**HARDEE COUNTY LANDFILL  
OPERATION PERMIT**

**SEQUENCE MOD. –**

Subject: Response to the Florida Department of Environmental Protection Comments  
Hardee County Class I Landfill Modification of Sequence of Filling  
Pending Modification #38414-004-SO to Operation Permit 38414-0020SO

On behalf of the Hardee County (County), SCS Engineers (SCS) is pleased to provide the following additional information requested in your correspondence dated February 20, 2001. For ease of review, we have provided the Florida Department of Environmental Protection (FDEP) comment or question in bold, followed by SCS' response.

Figure - Slope Stability - Current Permit BY PBSJ

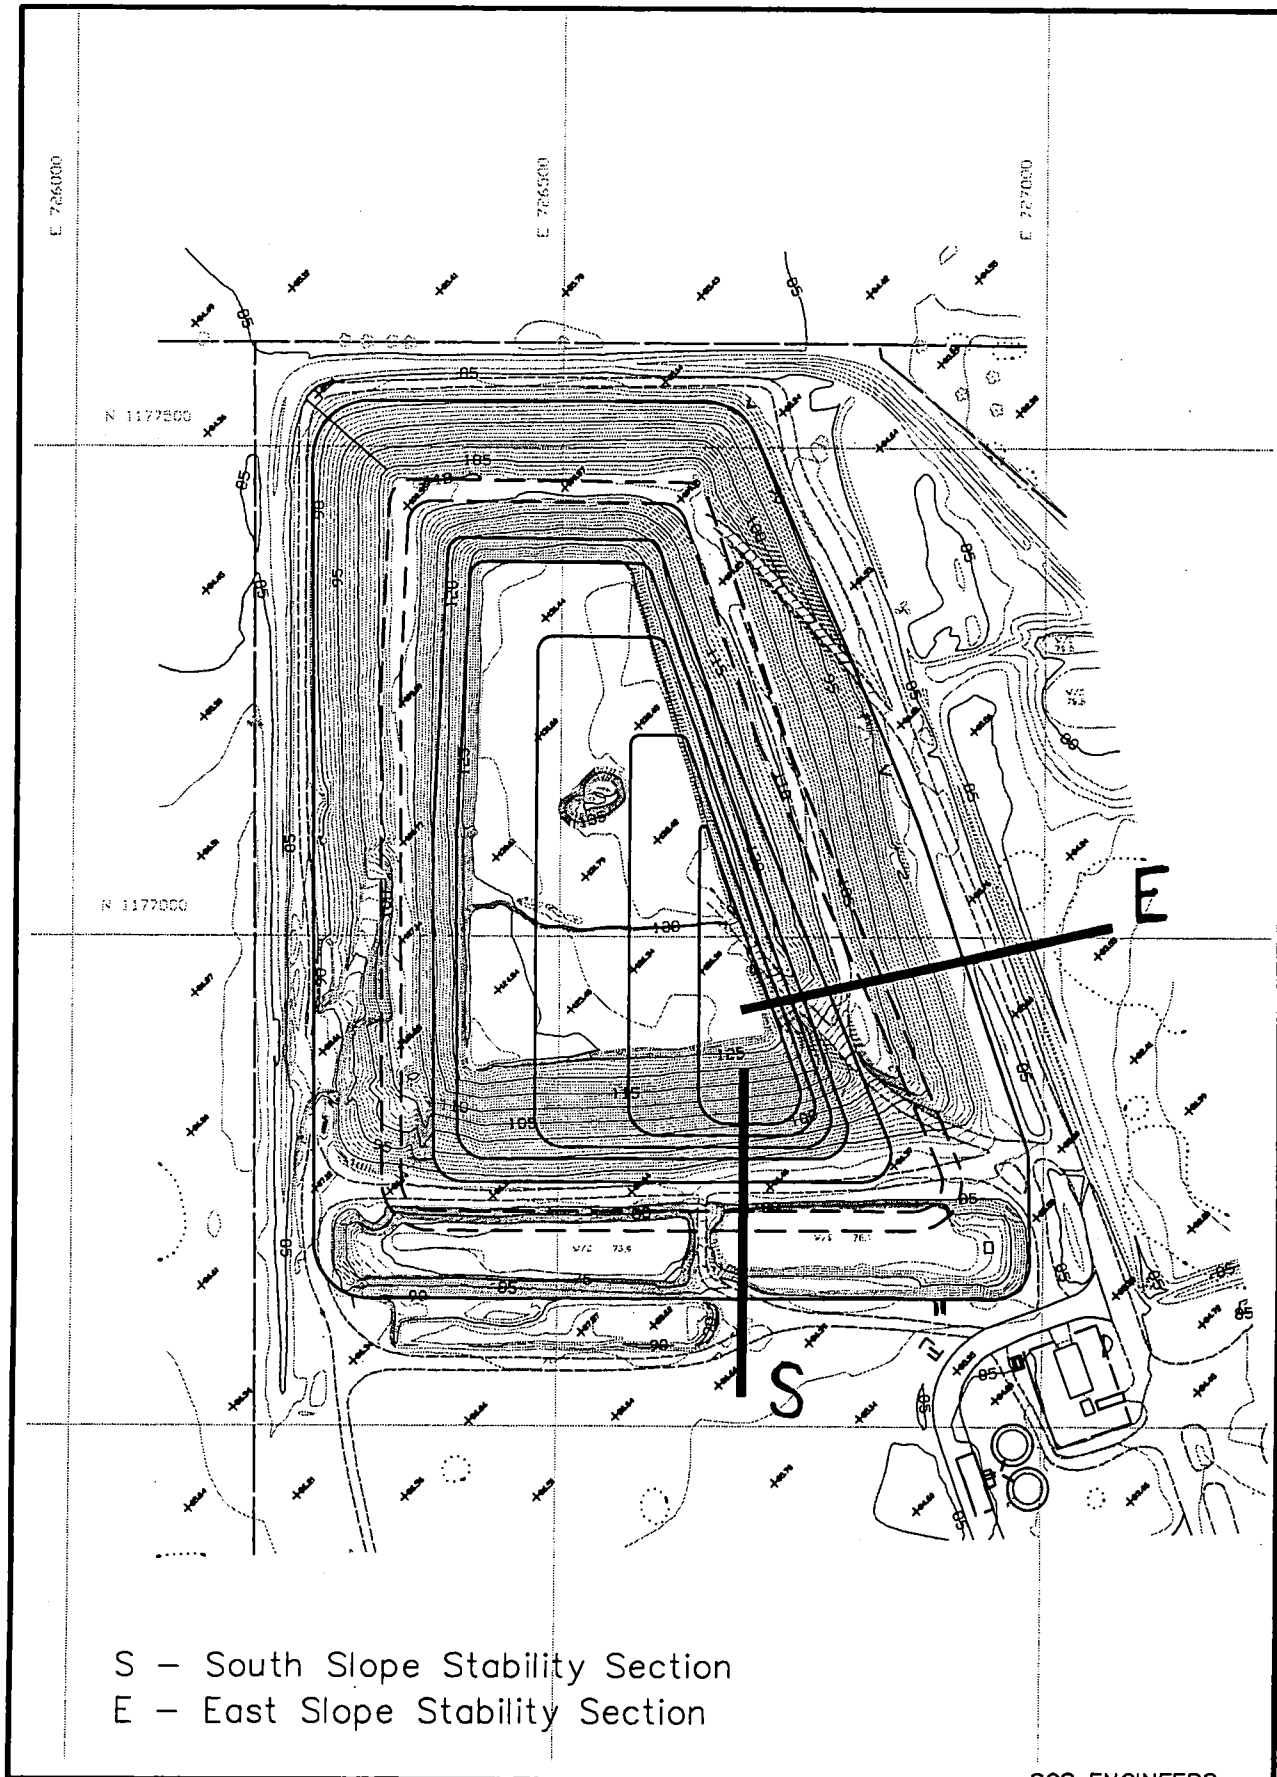
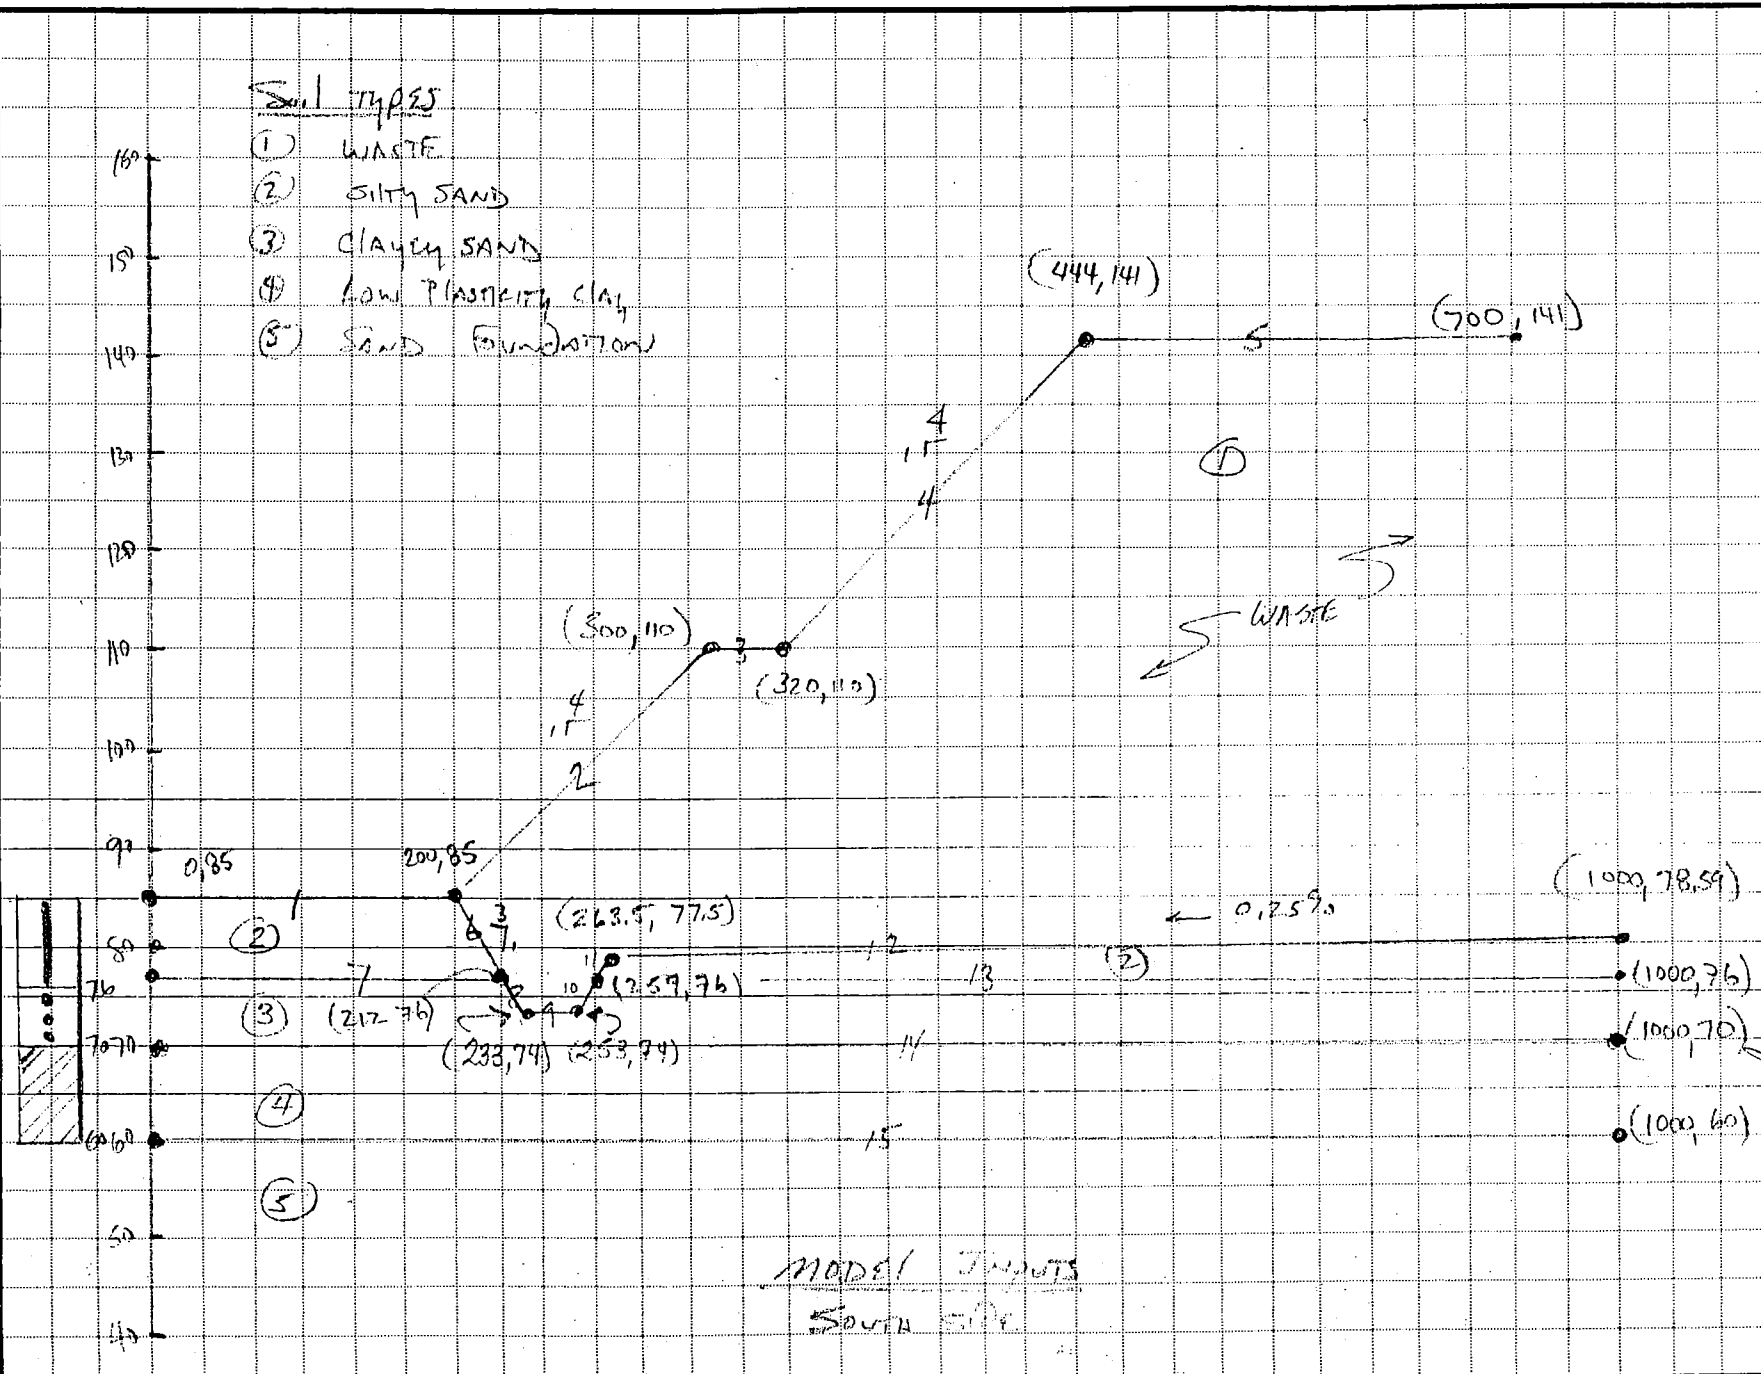
- 3) **The "existing" case includes 3H:1V sideslopes. However, Sheet 7, "Sequencing Plan, Sequencing Plan, Sequence 7 and Details," dated June 26, 1997, prepared by PBSJ, shows the maximum slopes are 4H:1V (north and east slopes). Please revise the "existing case" calculations to reflect these slopes. Please note also that the west and south slopes ("existing") are much less steep are not considered to be the "worst case" slopes of concern.**

Response - SCS has recomputed the “existing” or “current” permitted sideslope design into the slope stability calculations. The electronic files received from PBS&J have sideslopes on the south and east side varying from 3.5 to 4 (H): 1(V). SCS used 4(H):1(V) sideslopes in the recomputed “existing” slope stability. A 4(H):1(V) is the best case scenerio and the Factor of Safety for steeper sideslopes would be between the “existing” 4(h):1(V) design and the proposed 3(H):1(V) design. The proposed design by SCS is stable with 3(H):1(V) sideslopes.

Figure - Sideslope Compaction

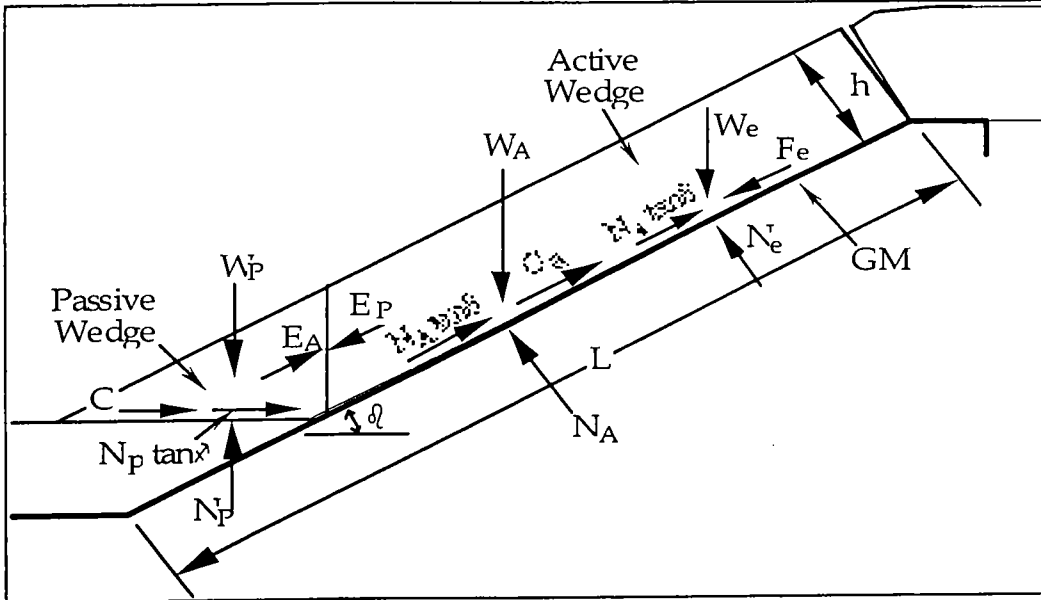
1. **Rule 62-701.500(2) (f), F.A.C. Method and Sequence of Filling.**
  - a. The information states, "due to the rectangular shape of the bale, loose unbaled material will be placed along the sideslopes to achieve the grades shown on the drawings." (page 1) This method of filling does not correlate with the current Operations Plan. Since the bale lift height is less than 6 feet (see Operations Plan, Figure 7-1), it does not seem likely that loose waste can be placed and adequately compacted in the "steps" created by the bales at the slopes. An evaluation of the slope stability under this condition was not provided.

Response - Please refer to the figure in Attachment C for the proposed placement along the sideslope. The loose fill will be placed and compacted along the sideslope to efficiently utilize airspace using the County's CAT D7H dozer. The initial placement of bales will be offset from the slope approximately 20 feet, minimum, to allow the dozer working room. The following bales will be offset from the initial bales, as shown on the figure, to roughly approximate the sideslopes. The dozer will place loose waste along the sideslope to achieve the sideslope shown on the drawings.

Equipment Loading of Sideslopes Hardee County Landfill Hardee Co, FL  
Ten Most Critical. C:EQUIP.PLT By: Joseph O'Neill 04-15-01 8:41 pm

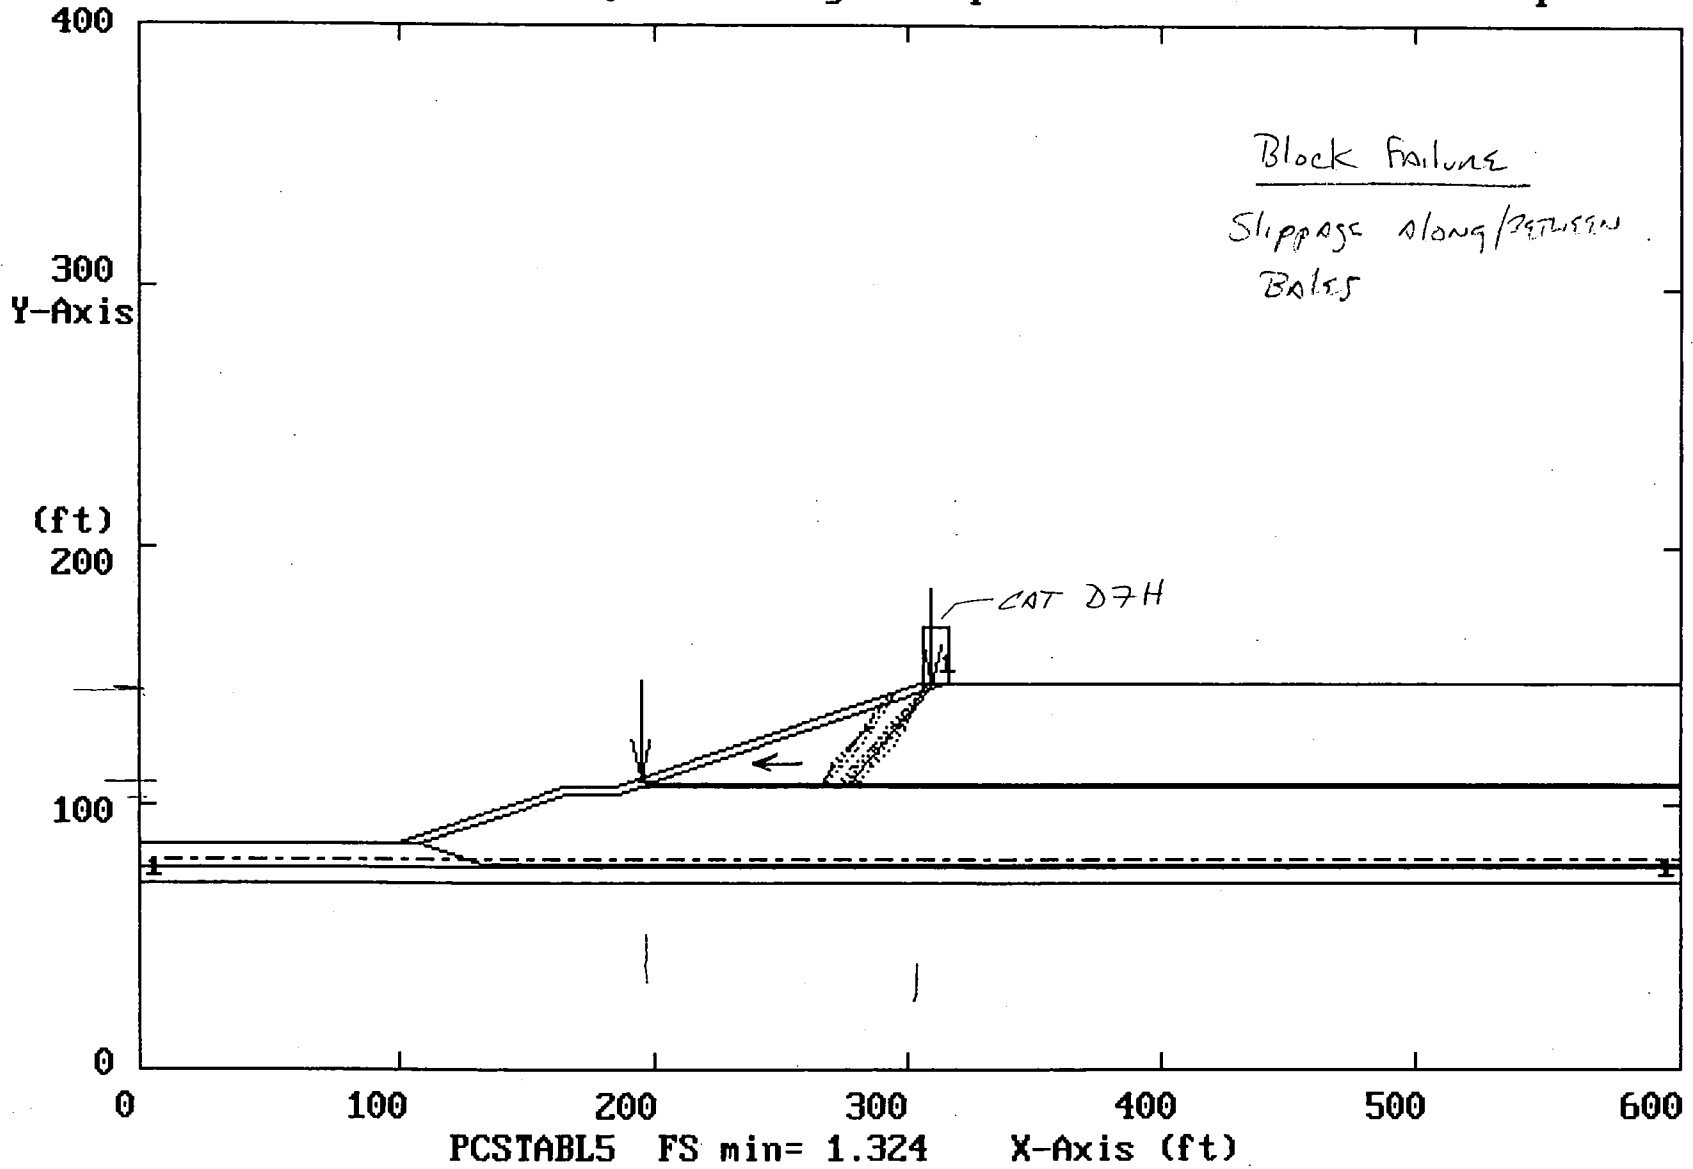
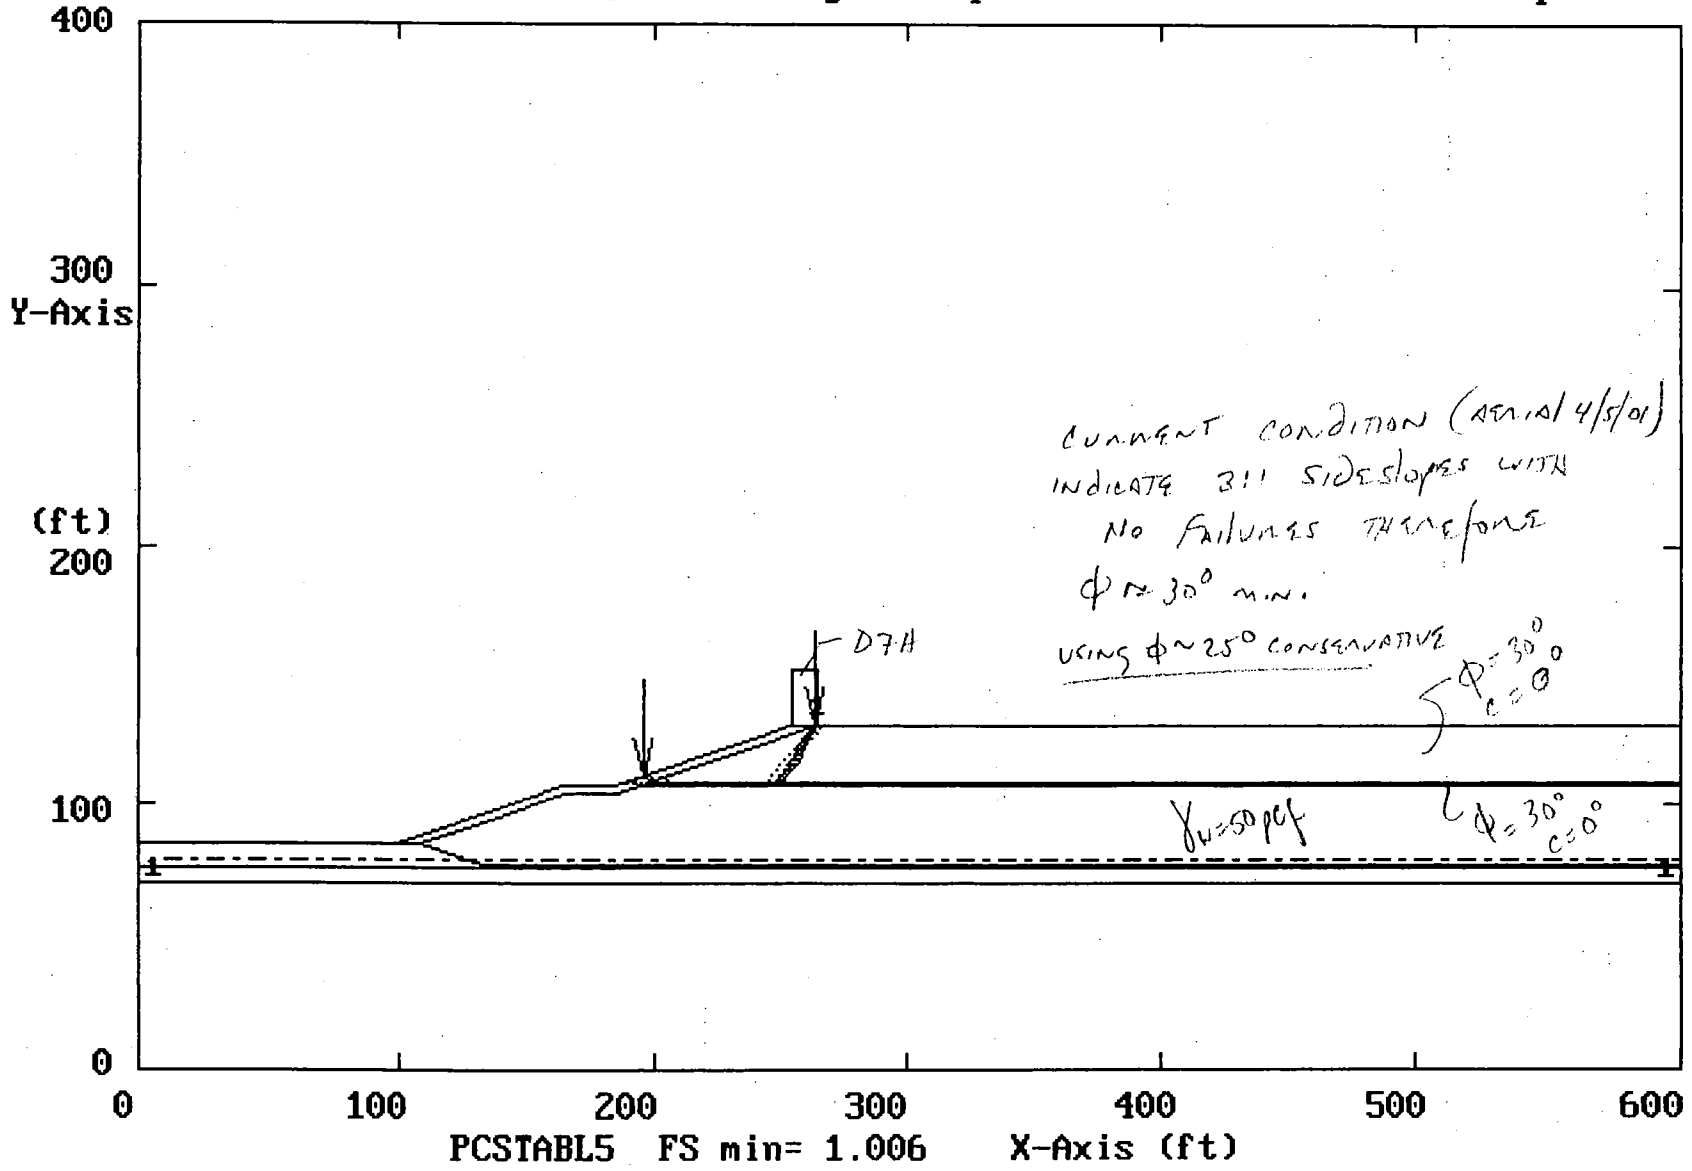
- 4) **Please provide calculations which demonstrate that the slopes will be stable considering the method of placing bales to a 3H:1V slope with the facility's equipment.**

Response - Please refer to Attachment D.
